Air Quality CEQA Analysis and Consulting Services

RE: Harvard Westlake RDEIR ENV-2013-0150-EIR SCH NO. 2013041033; Air Quality Analysis and Comments

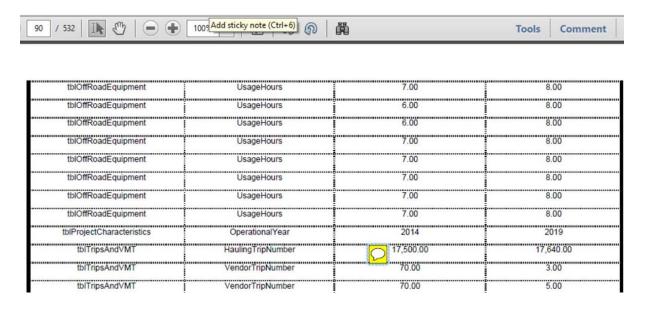
At various locations in the RDEIR project duration is identified as 30 months, an increase of five months over that shown in the DEIR. However, CalEEMod modeling output sheets provided in the RDEIR's Appendix C shows construction across 4 years (2016 – 2019), with construction phases likely extending to 42 months. This is a significant unexplained discrepancy between information found in the RDEIR and Air Quality Appendix C. Project timing and duration are important to emissions estimation, but because assumptions regarding inputs used in the CalEEMod model have not been provided by the Lead Agency, discrepant timing/duration information between the RDEIR's elements and CalEEMod output sheets in Appendix C cannot be logically resolved by the RDEIR's reader.

The CalEEMod output sheet excerpted below (pg. 90 of 532) reflects 17,640 haul trips, but no information is provided in the RDEIR's Air Quality element to explain how this value was determined.

phase of the project--yet this trip estimate varies substantially from the unexplained 17,640 trips identified in the screen shot, above, and we are unable to tell how many yards were estimated per truck trip or whether the 17,640 value in the excerpt above represents all hauling trips or some combination of hauling-plus-other trips, or as one- or two-way roundtrips.
